Technical Note

DA7219 Updated Ball-out

This document describes the changes made to the ball-out of the DA7219 device to add a GND_HP ball.

Figure 1 Comparison of original ball-out to new ball-out (changes highlighted in red)

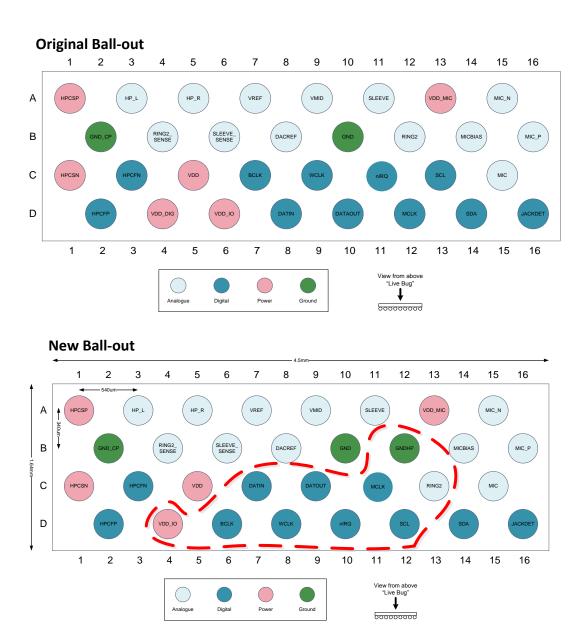
The new ground ball replaces the VDD_DIG ball and moves 7 balls to allow for optimal placement of the new ball. The VDD_DIG ball was previously used to attach a bulk capacitor to the output of the internal digital supply LDO. This LDO is not required so this ball has been repurposed as a ground. The updated ball-out can be seen in Figure 1.

Figure 2 Original Schematic vs Updated schematic

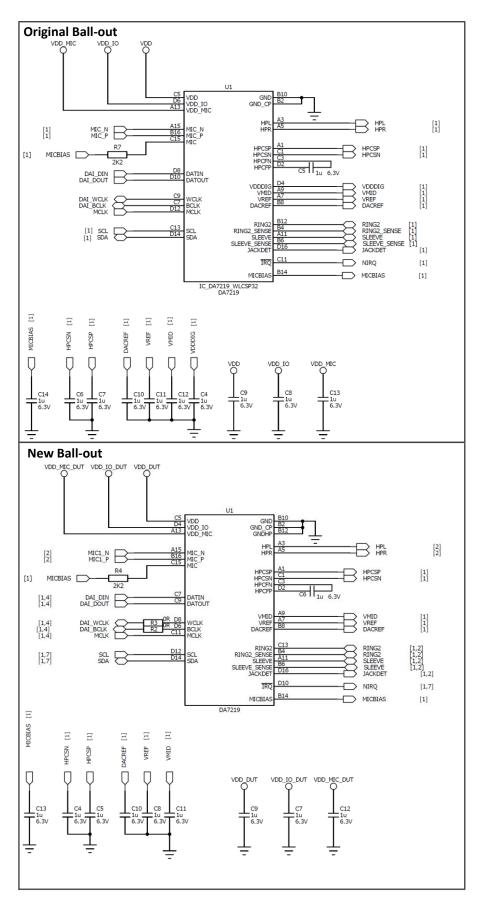
The reference schematic has been updated for the updated ball-out. A comparison between the original schematic and the updated schematic is shown in Figure 2. The ball-out change saves one capacitor compared to the original.

Figure 3 Original Layout vs Updated Layout

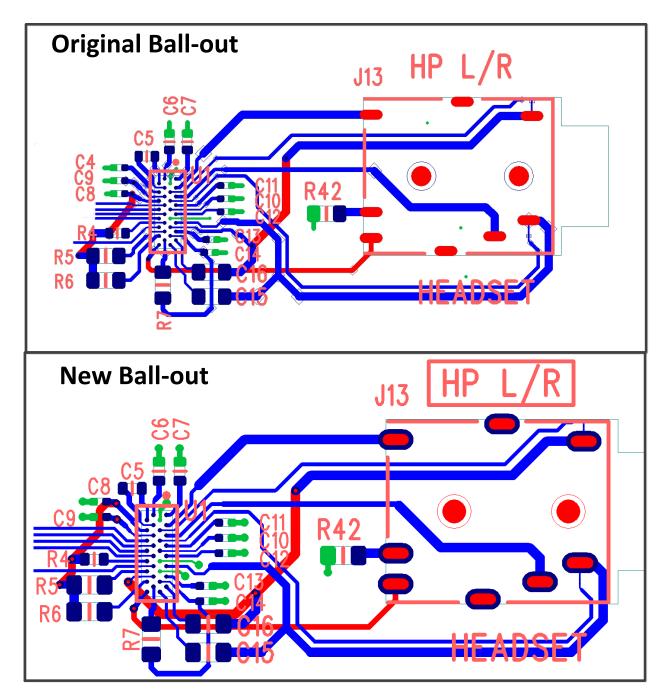
The reference layout has been updated for the updated ball-out. A comparison between the original layout and the updated layout is shown in Figure 3.
